Memo

To: The Atherton Planning Commission
From: Sally D Bentz, Town Arborist
CC: Laylonni Laster, Assistant Planner
Date: April 2nd, 2025
Re: Heritage Tree Removal Application at 170 Atherton Ave.

SITE PLAN - ALT 1

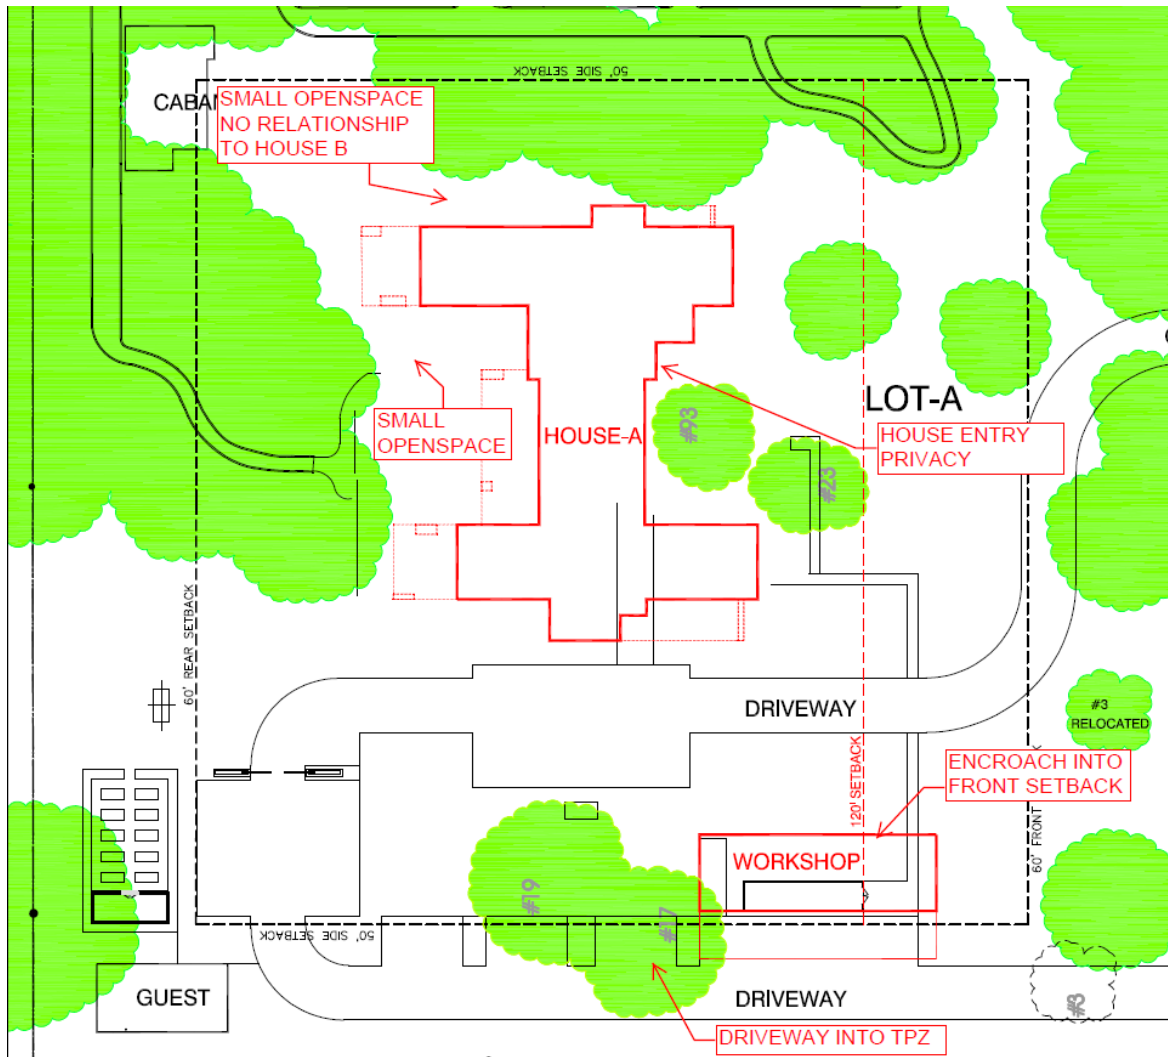
Alternative Location 1: location 1 the proposed main house encroaches on additional healthy trees.

Tree #23 – The tree is located where the proposed main house is located. The applicant states there is no feasible alternative placement without causing greater harm to other protected trees or making access to the home impossible. Alternative #1 would encroach into the TPZ's of multiple trees that would require removal. Per Mr. Kielty, fertilization and soil decompaction measures were completed last year and the tree continues to decline. Multiple cables have been installed in the tree's canopy to mitigate the poorly formed codominant union at 2' with included bark. This tree is not expected to improve with any possible mitigation measures; therefore, the tree is considered hazardous and is recommended for removal.

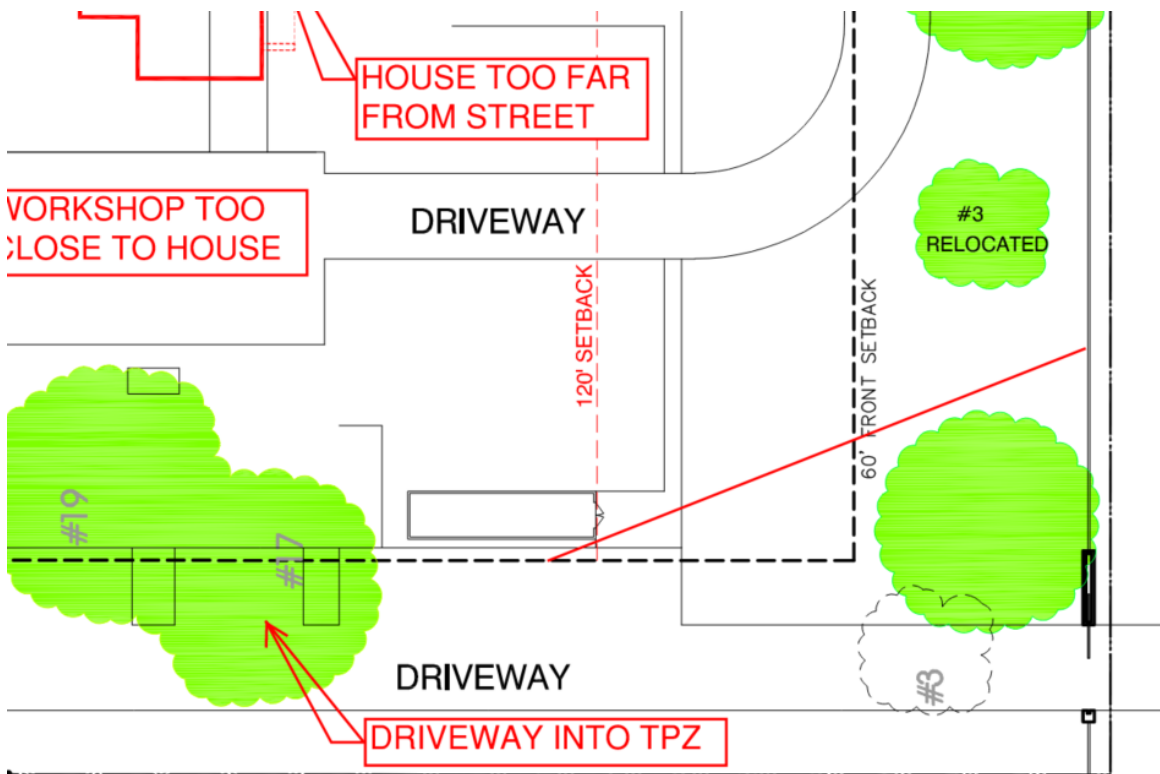
Tree #3 – The tree is located in the proposed driveway. However, the tree has shown signs of improvement. Mr. Kielty states that following targeted fertilization treatments, the tree has responded well, exhibiting enhanced vigor and foliage density. With its well-balanced canopy and structurally sound form, it is now considered a strong candidate for successful relocation.

For moving tree requests we treat them like removals. If the tree is moved and dies within 5 years, we can assess a fine on the tree. Because the tree is seeing signs of recovery, I do not think it should be moved. I think the driveway location can be moved. Below I marked with a red line where the driveway could be without removing tree #3.

If the Commission wish to grant the moving of the tree than I recommend a condition of approval be that an appraised value of the tree times two would be the fine for if the tree dies within 5 years. Also, a condition would be to follow Mr. Kielty’s recommendations regarding transplanting.
